Access Compliance Report

Public Rights-of-Way

(Curb Ramps)

Intersection ID: 50927	Main Street: LANDING_PLACE_LN	Cross Street: LANCASTER_HY	Location: SW
ADA ID: E3F01862B46D	Ramp Type: PerpDiag	Initial Pass/Fail: Fail	Overall Compliance: No
Severity Score: 12.5			
Codes/Mitigation Info/Possible Solution		Field Measurements/Component Compliance

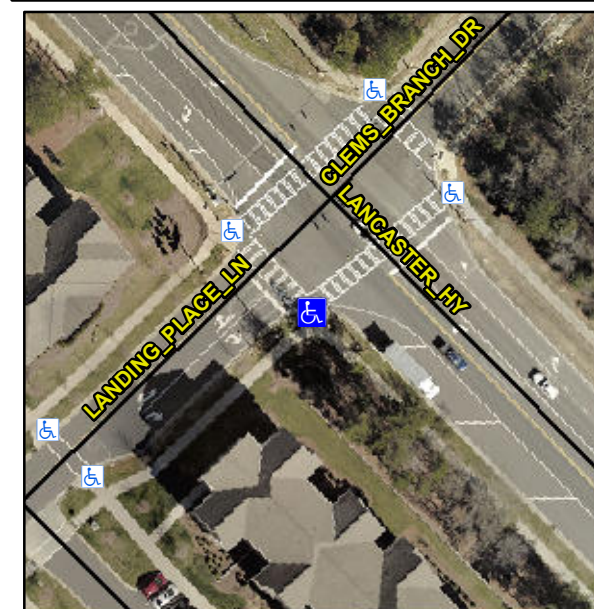
R304.5.3

Compliance	Description	Data	Compliance	Description	Data
N/A	Ramp Length (in)	96.0	Yes	Ramp Slope (%)	5.2
Yes	Ramp Width (in)	60.0	No	Ramp XSlope (%)	5.3
N/A	Flare Type LT	N/A	N/A	Flare Type RT	N/A
N/A	Flare Slope LT (%)	N/A	N/A	Flare Slope RT (%)	N/A
N/A	Flare Traversable LT?	N/A	N/A	Flare Traversable RT?	N/A
N/A	Landing Length (in)	N/A	N/A	DWS Provided?	N/A
N/A	Landing Width (in)	N/A	N/A	DWS Contrast?	N/A
N/A	Landing Slope (%)	N/A	N/A	DWS Length (in)	N/A
N/A	Landing X Slope (%)	N/A	N/A	DWS Full Width?	N/A
N/A	Landing Curb? (Y/N)	N/A	N/A	DWS Offset (in)	N/A
N/A	Shared Landing?	N/A			
N/A	Gutter Ponding?	N/A	N/A	Gutter Slope (%)	N/A
N/A	Gutter Lip Ht (in)	N/A	N/A	Gutter X Slope (%)	N/A
N/A	Painted X Walk1?	No	N/A	Painted X Walk2?	Yes
	X Walk 1 Direction	To NE		X Walk 2 Direction	To NW
N/A	X Walk 1 Width (in)	N/A	N/A	X Walk 2 Width (in)	87.0
	X Walk 1 Slope (%)	3.0		X Walk 2 Slope (%)	1.1
	X Walk 1 X Slope (%)	4.8		X Walk 2 X Slope (%)	6.4

Remove & Replace Curb Ramp With Two New Directional Ramps or Equivalent.
